# BCA Assessment Report

Stage 2 West Link Industrial Estate  
292 – 308 Aldington Road

**Revision 1**  
03 October 2023  
Reference: 220278

Figure 2 External Walls & Columns located within 18m of side allotment boundary

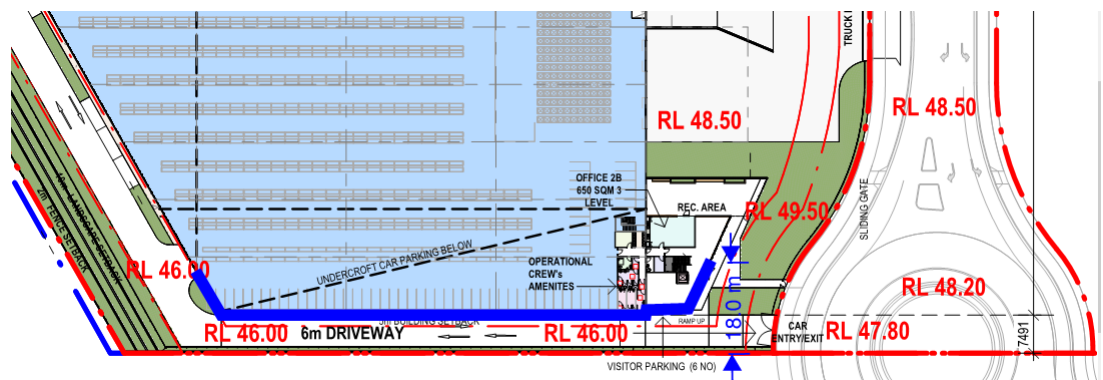
- + External Walls and external columns located less than 18m from the southern allotment boundary are required to achieve an FRL in accordance with Table S5C21a – see mark-up in Figure
- + Any Fire Walls that are proposed to separate different classifications per C3D9 above are to achieve the required FRL per Table S5C21d: 240/240/240 FRL.
- + All internal load-bearing columns, & walls (excluding those providing direct support to the roof only) are to achieve the required FRL per Table S5C21g: 240/- FRL. Note: Applies to columns supporting the mezzanine in Warehouse 8A.

**Note:** Any proposal to reduce the FRLs of building elements that are required to be fire rated must be addressed as a Performance Solution from the Fire Engineer.
